PLANNING COMMISSION STAFF REPORT

AGENDA ITEM: **Planning File No. MAJ-26-0003:** A sketch plan review of the Major Site Plan application for a proposed residential development consisting of eight (8) new townhomes.

LOCATION: 207 Granite Street / Lots 13-18, Block 8, Frisco Town Sub

Proposed and existing non-vehicular pathways

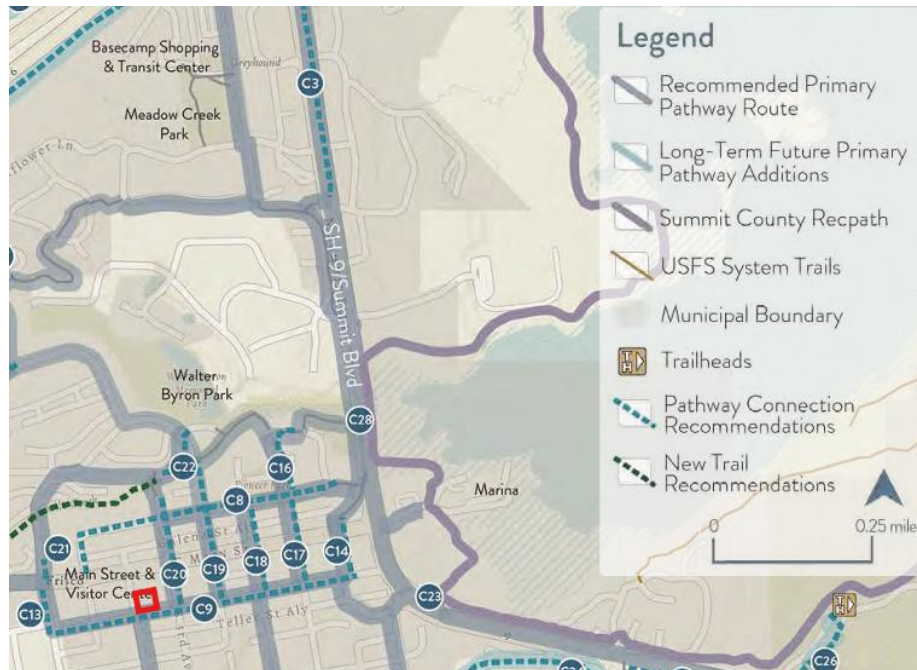
For units along Granite Street and S. 2nd Avenue, the application materials show walkways connecting each unit to the nearest public street. The units along the alley side show a sidewalk connecting to the dumpster enclosure and out to the sidewalk along S. 2nd Ave. An additional walkway connects the internal garage areas to the dumpster enclosure. These walkways must be paved.

Recommendations from the 2023 Frisco Trails and Pathways Master Plan

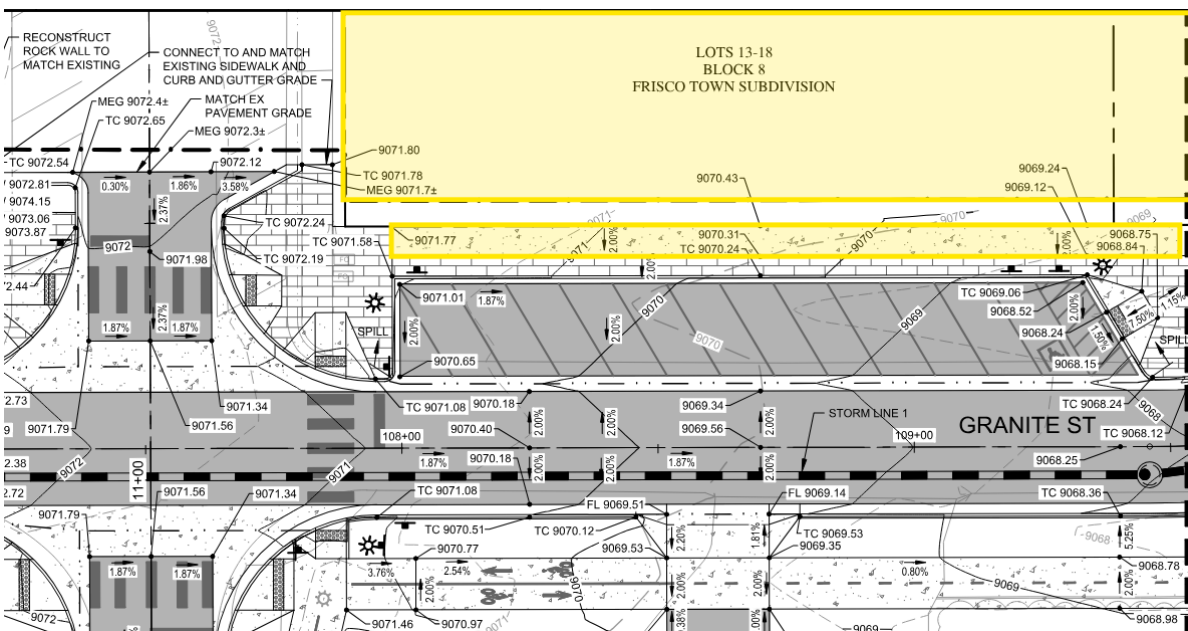
The 2023 Frisco Trails and Pathways Master Plan shows a separated multi-use path along Granite Street adjacent to the proposed development as part of the Downtown Complete Streets Plan. The latest plans for Complete Streets, provided by the contracted Town Engineer, show a 6-foot sidewalk with diagonal parking adjacent to the subject property. Staff strongly recommend that the applicant review the planned design for Granite Street and add the proposed sidewalk connection at a minimum for improved pedestrian safety for the development rather than connecting the walkways for each unit on this side to the roadway on Granite Street. The Town cannot require the applicant to build the sidewalk at this time.

Snow storage plan for alley-facing units

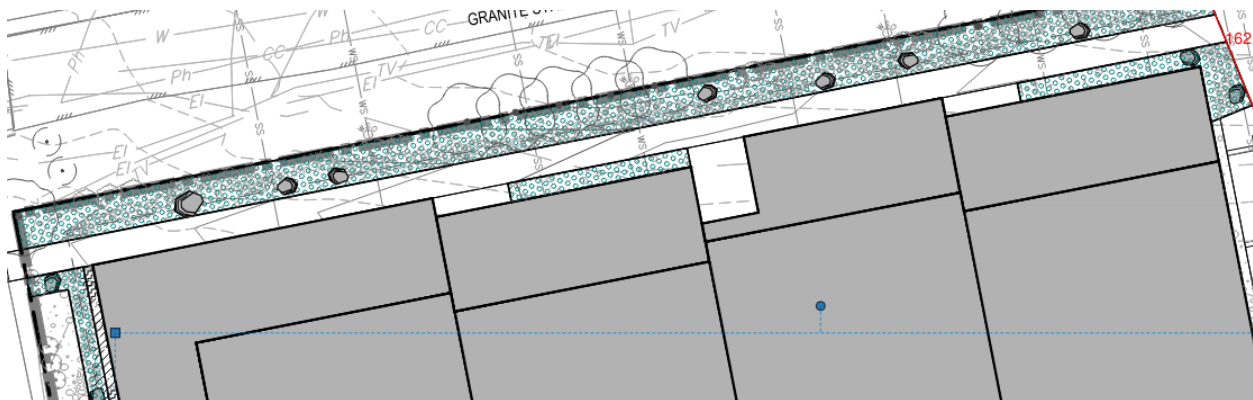
The application materials show that the total snow storage meets the 25% quantity requirement, but additional information will need to be provided at final site plan submittal measuring each applicable surface area individually and the snow storage quantity adjacent to each area. Staff does not have concerns about the 8-foot width requirement. Snow storage also

must be provided for the uncovered portions of upper level decks. The applicant will need to clarify how the snow from uncovered decks on the alley side will not be deposited on the pedestrian walkway on that side:

North Building, North Elevation – facing alley. Yellow outlines show areas providing relief from duplication of units.

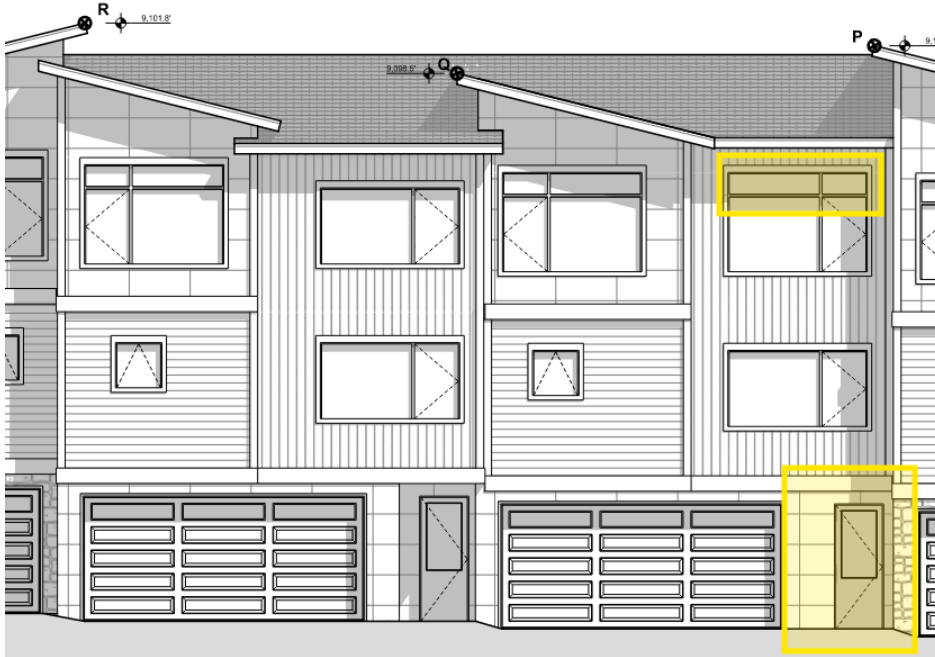
The application materials show two new buildings that are similar to one another but not duplicative. Within each building, some units are similar but none are exact duplicates. The most similar unit facades are facing the internal driveway, not facing streets. Variation is provided with siding materials, windows, entrance locations, roof planes, and more. Examples of differences between two similar units on the north building are shown below. The south building has similar duplication on the middle two units.

Staff requests that the Planning Commission provide feedback to the applicant on the building design variety.

Building areas with potential snow shedding concerns

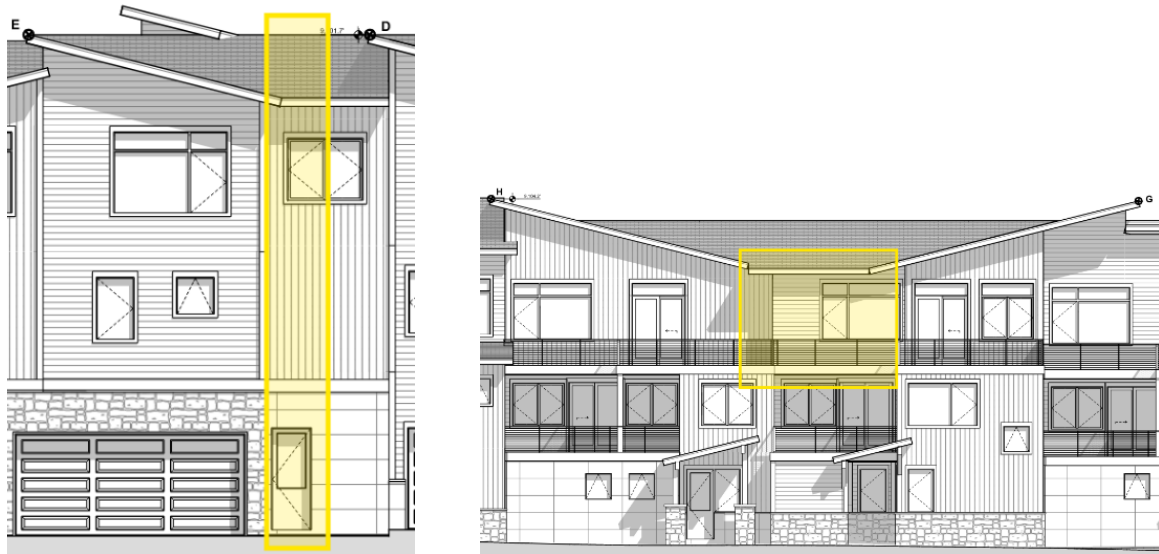
All roof pitches are proposed to be pitched at 3:12, except for some lower-level roof elements that are 2:12 or 4:12. All roof elements are proposed to have shingles, color “Weathered Wood,” meeting the requirements. There appears to be potential snow shedding issues as identified in images pasted below which should be addressed at time of full site plan application submittal.

1 NORTH BLDG BULK PLANE ENCROACHMENTS
(A-11)

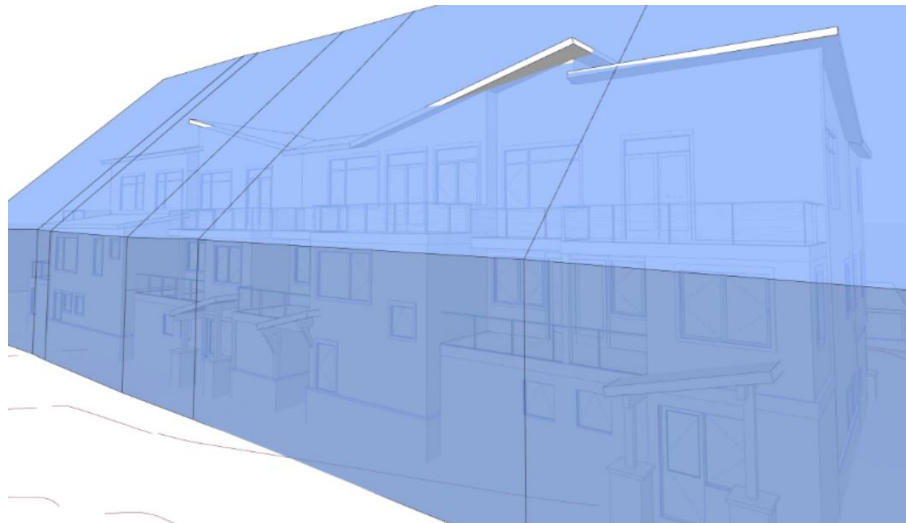
The application materials show bulk plane renderings and calculate 200 cubic feet of total bulk plane encroachments. The bulk plane encroachments appear to be just for roof eaves. Planning Commission should comment on whether the proposed bulk plane encroachments provide substantial architectural relief.
